Re: Moving septic easement for Big Branch Overlook Lot 30 - Plat Number 13855
(14100 Big Branch Drive Tax Map 27, Grid 6 – Parcel 140.141.142)

Revised Percolation
Certification Plan

PROJECT: BIG BRANCH OVERLOOK LOT 30	
LOCATION: 14100 BIG BRANCH DRIVE TAX MAP 27, GRID 6 - PARCEL 140,141,142 5th ELECTION DISTRICT HOWARD COUNTY, MARYLAND	
TITLE: PLOT PLAN	
HOUSE TYPE: COVENTRY	
DATE: OCTOBER 10, 2001	PROJECT NO. 1322
SCALE: AS SHOWN	DRAWING 1 OF 1

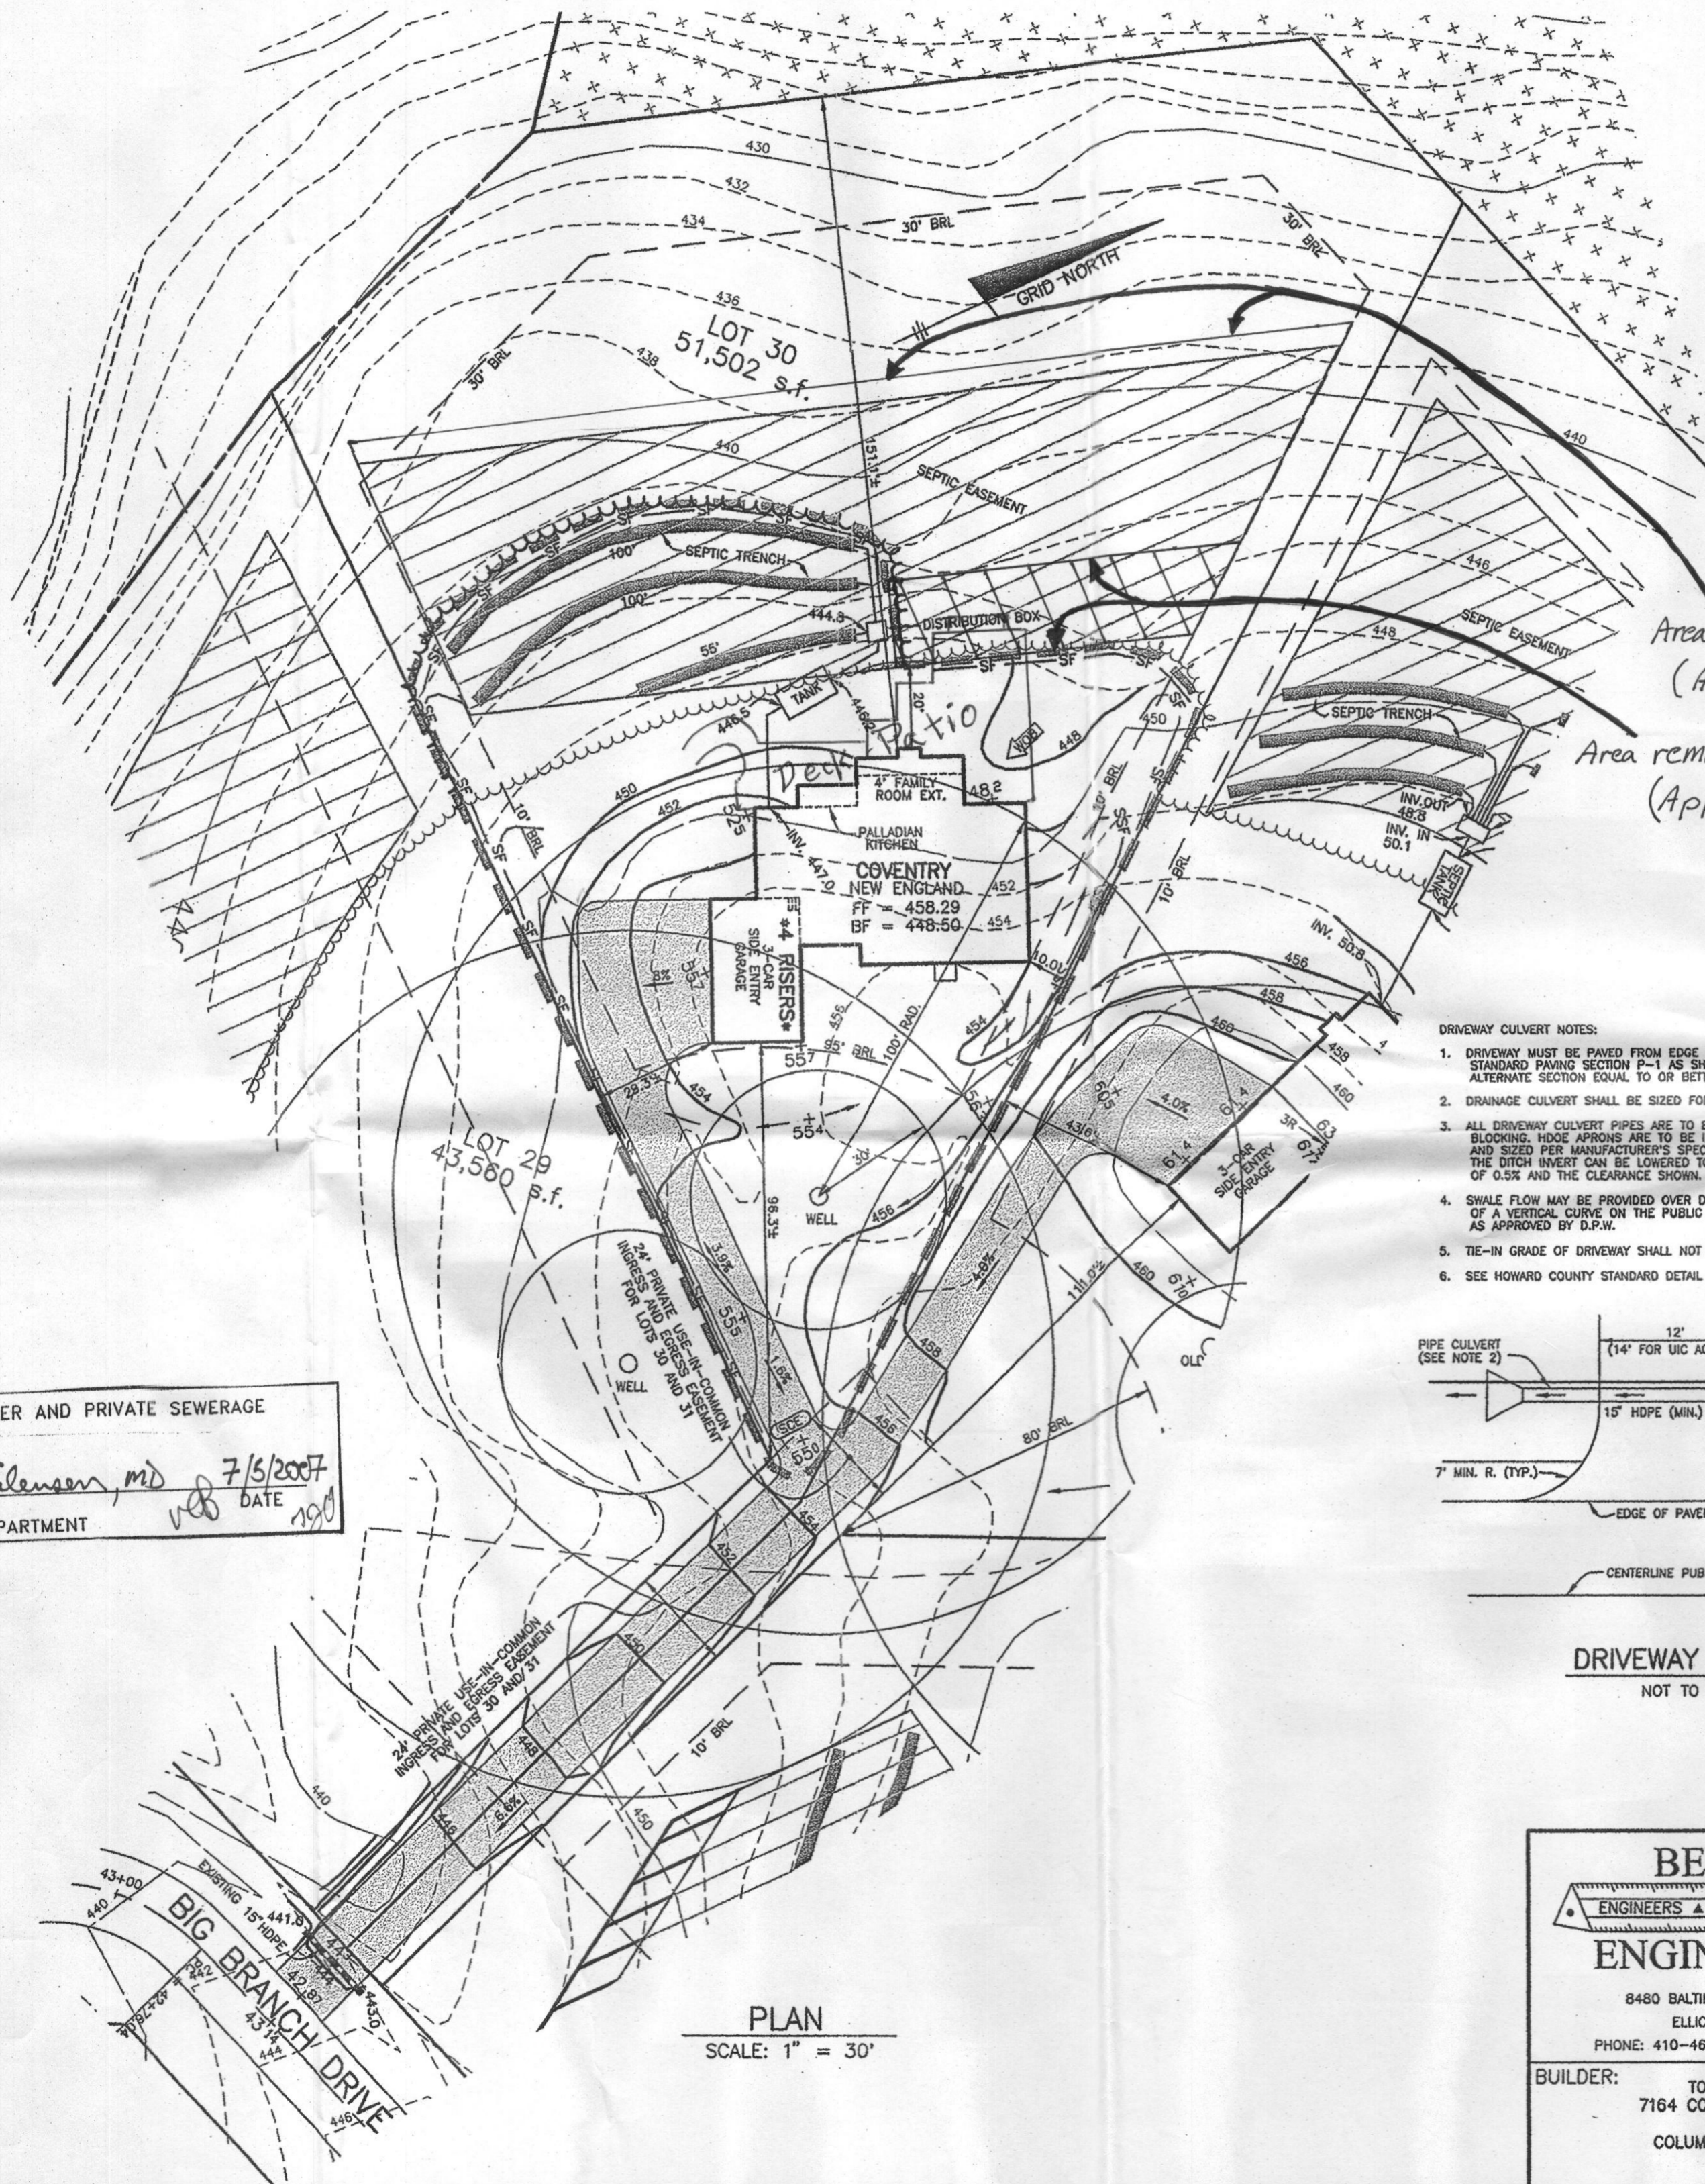
7. Adjusted septic easement area is approx. 10695 SF.
8. Purpose of Percolation Certification Revision is to accommodate a proposed patio.

Area added to septic easement
(Approx. 1175 SF)

Area removed from septic easement
(Approx. 1520 SF)

Revised Percolation Certification Plan

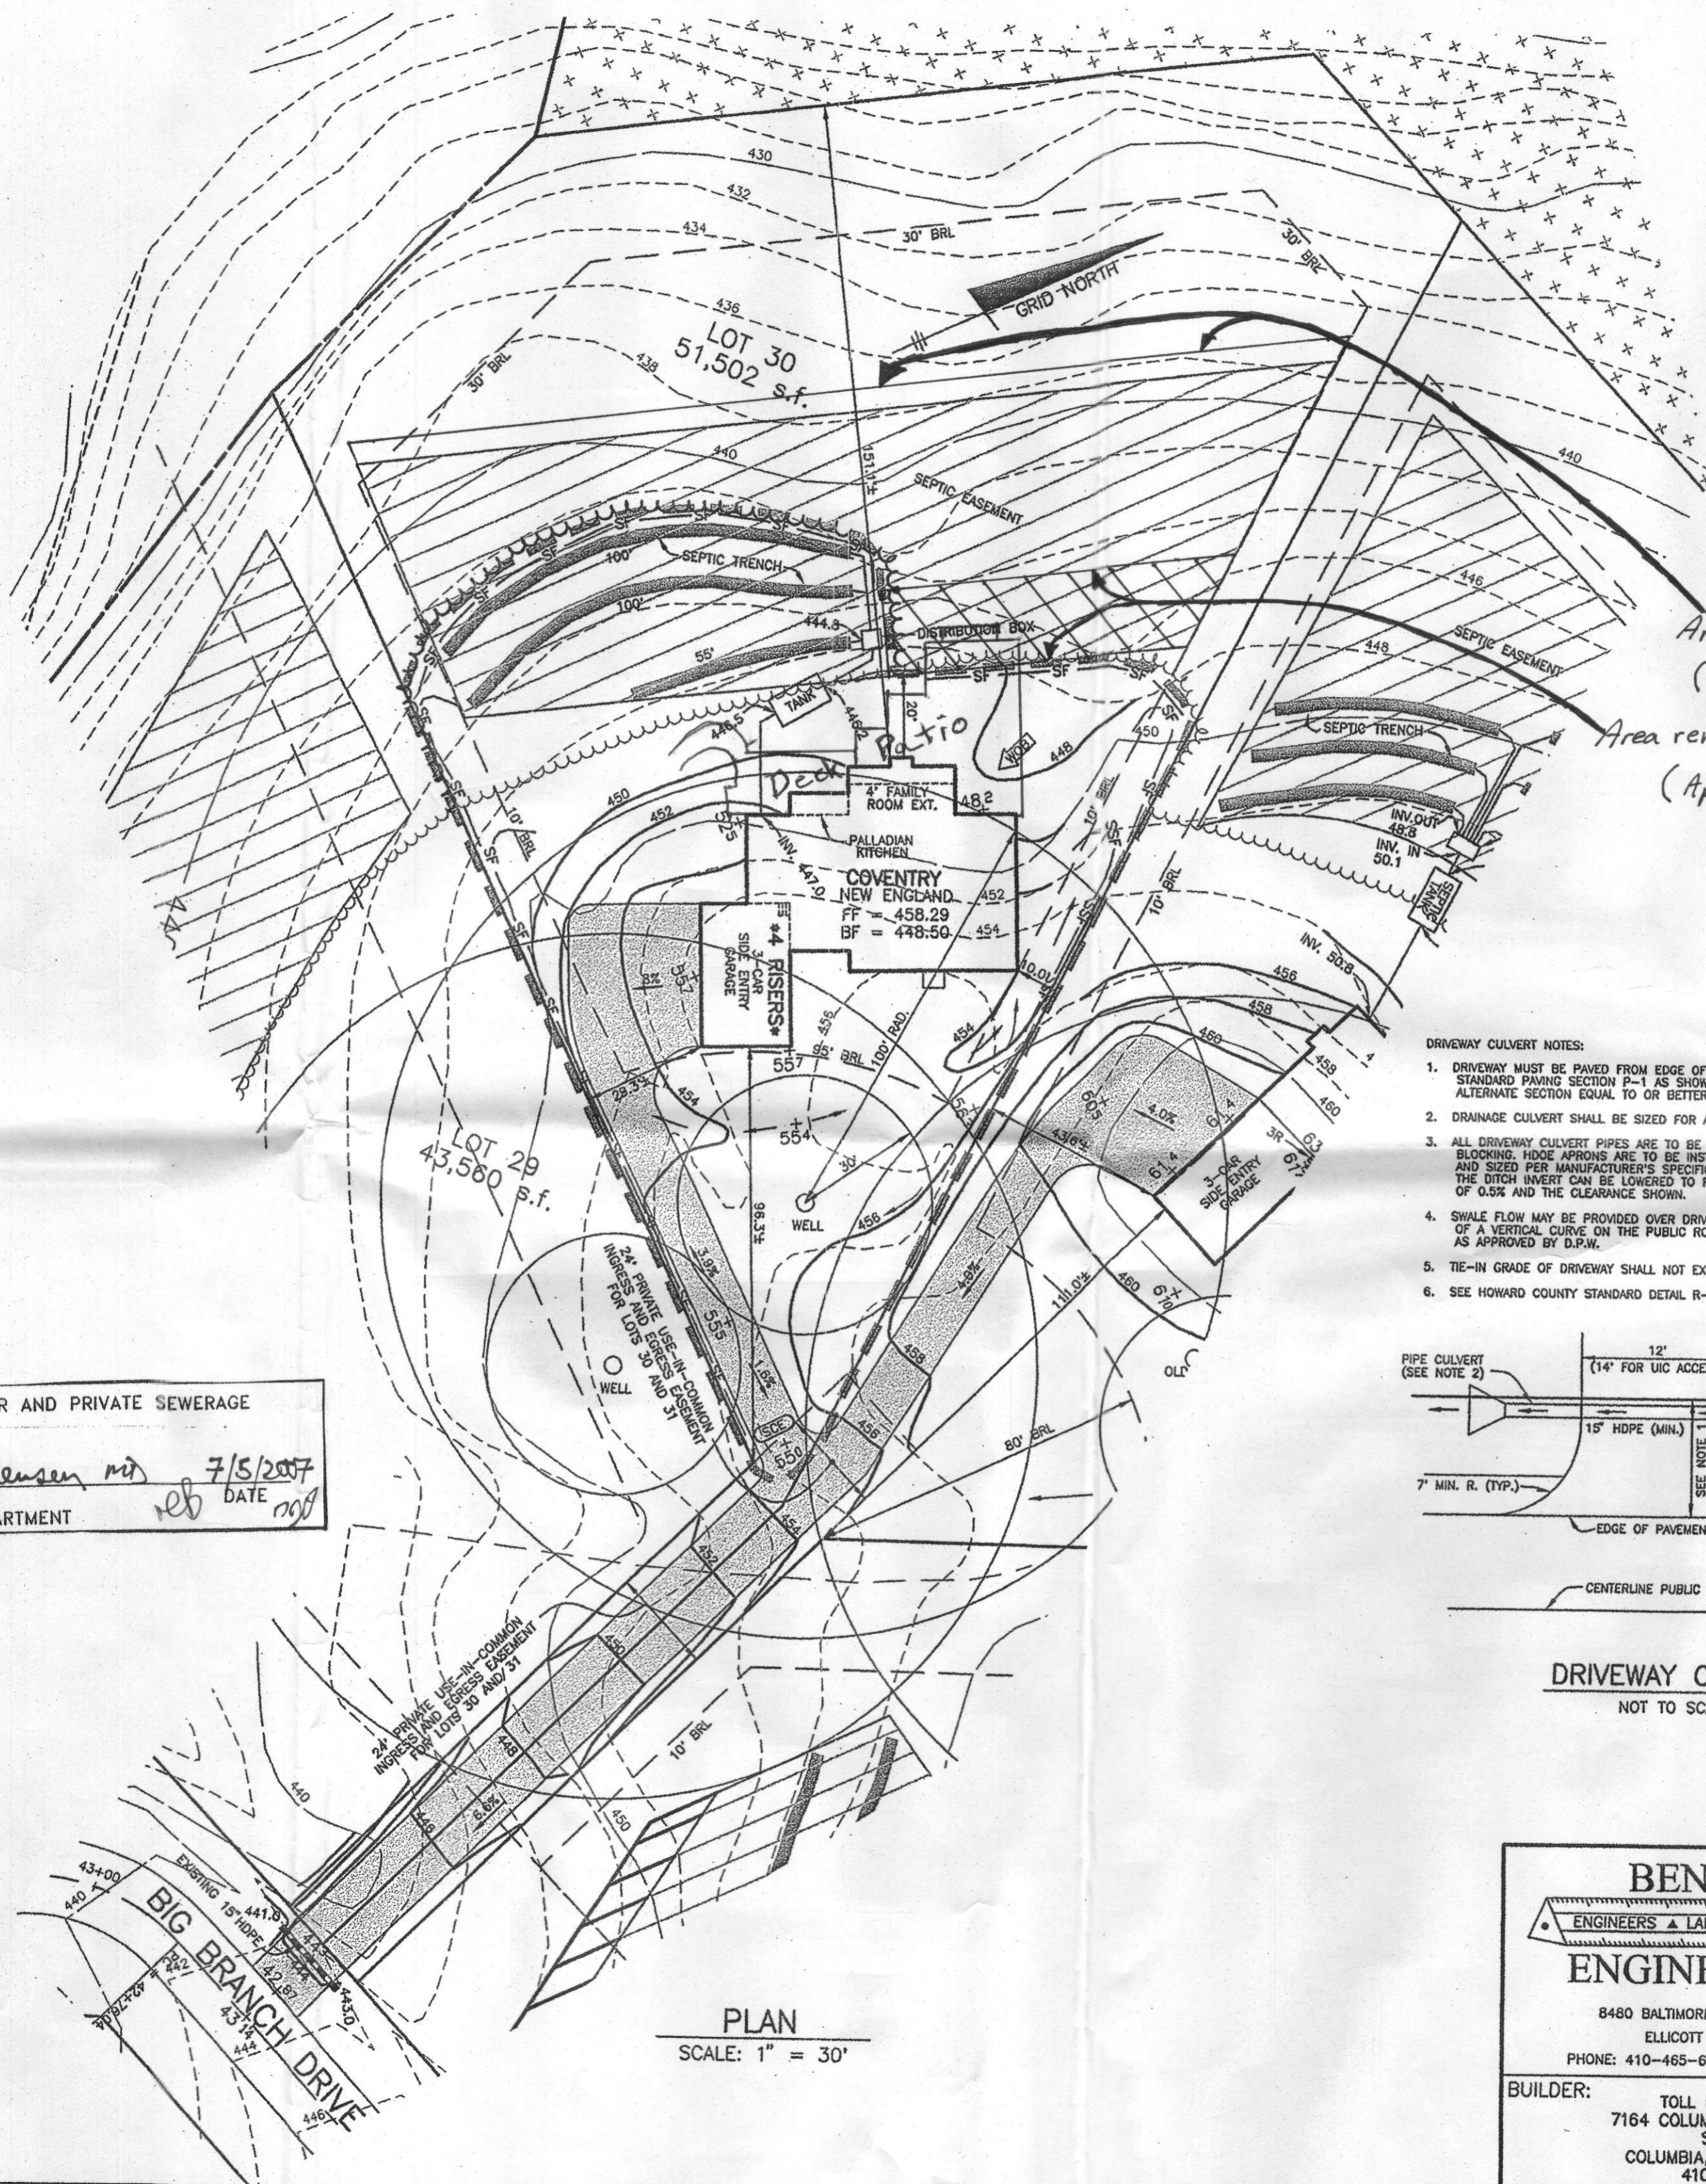
7. Adjusted septic easement area is approx. 10695 s.f.
B. Purpose of Percolation Certification Revision is to accommodate a proposed patio.

Area added to septic easement: **LEGEND**
(Approx. 1175 SF)
Area removed from septic easement
(Approx. 1520 SF)
